Appendix I of RNTPC
Paper No. A/YL-PS/734

**APPLICATION FOR PERMISSION
UNDER SECTION 16 OF
THE TOWN PLANNING ORDINANCE
(CAP. 131)**

(a) Proposed use(s)/development 擬議用途/發展	擬議臨時公眾停車場連充電裝置 (為期 3 年) Proposed Temporary Public Vehicle Park with Electric Charging Device for a Period of 3 Years (Please illustrate the details of the proposal on a layout plan) (請用平面圖說明擬議詳情)

寄件者: tmylwdpo_pd/PLAND
寄件日期: 2024年12月30日星期一 9:29
收件者: Max Yuet Lun WONG/PLAND
副本: Wai Lap TANG/PLAND; Spencer Ka Tsun LEUNG/PLAND
主旨: 轉寄: A/YL-PS/734 : 回應部門意見
附件: 回應部門意見.pdf

Drawing Title 圖紙標題:
Proposed FS Plan

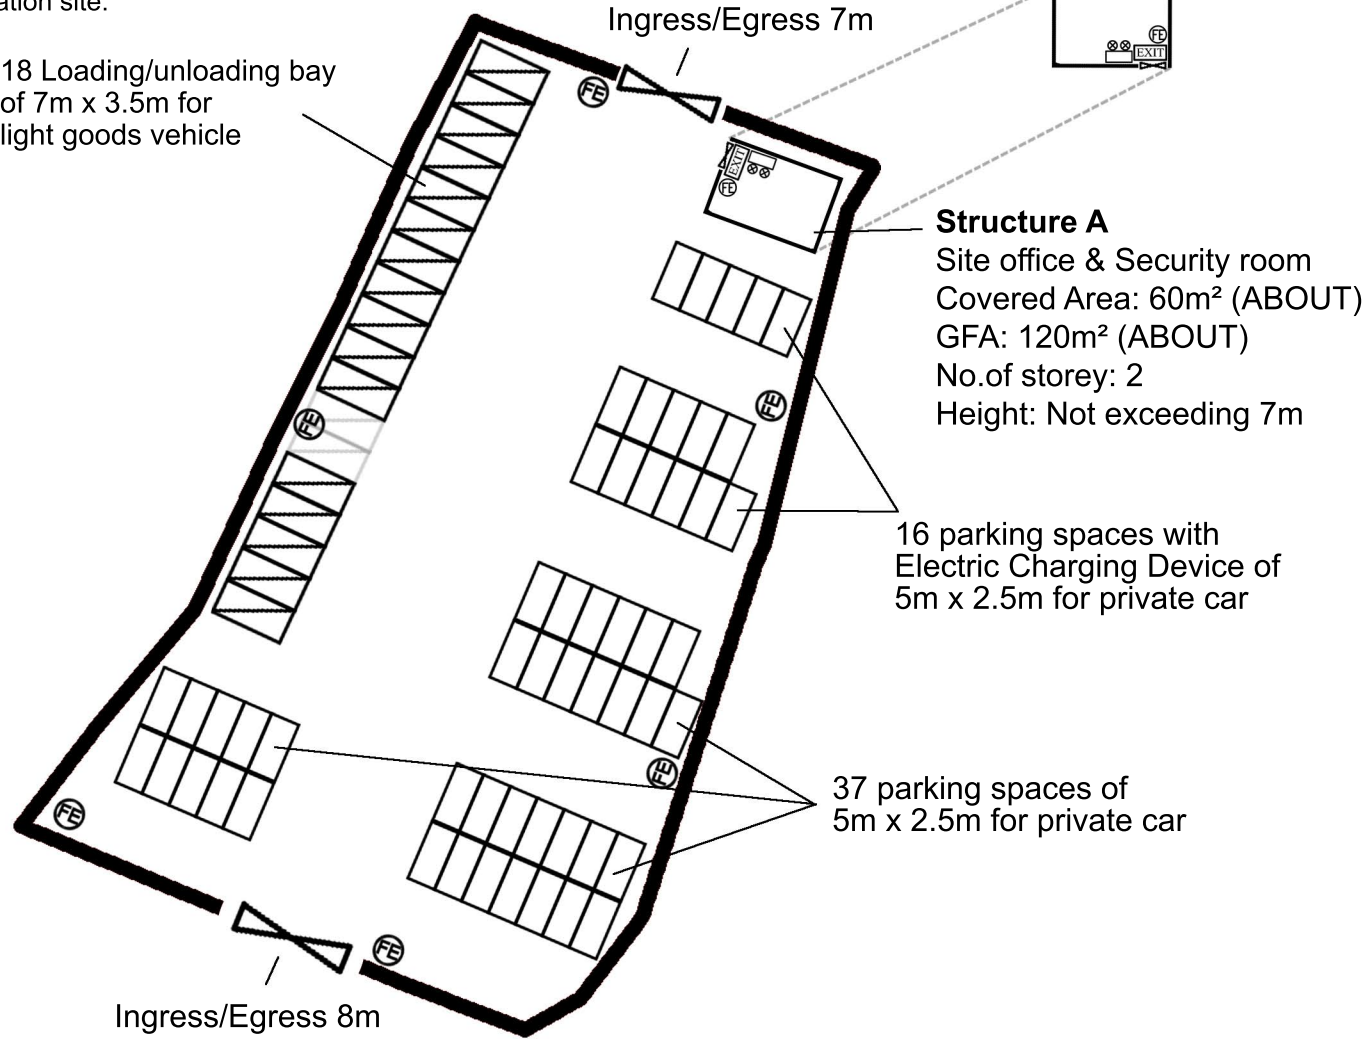
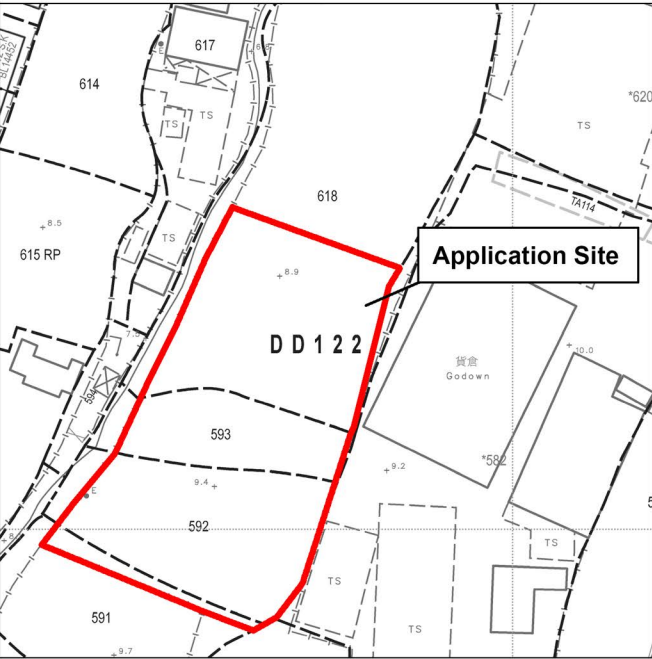
- (j) to note the comments of the Director of Fire Services (D of FS) that:
 - (i) in consideration of the design/nature of the proposal, fire service installations (FSIs) are anticipated to be required. Relevant layout plans incorporated with the proposed FSIs should be submitted to his department for approval;

- (ii) the layout plans should be drawn to scale and depicted with dimensions and nature of occupancy, and the location of proposed FSIs to be installed should be clearly marked on the layout plans;

- 1. Portable fire extinguisher shall be provided throughout the application site.
- 2. Portable Sand Bucket shall be provided throughout the application site.
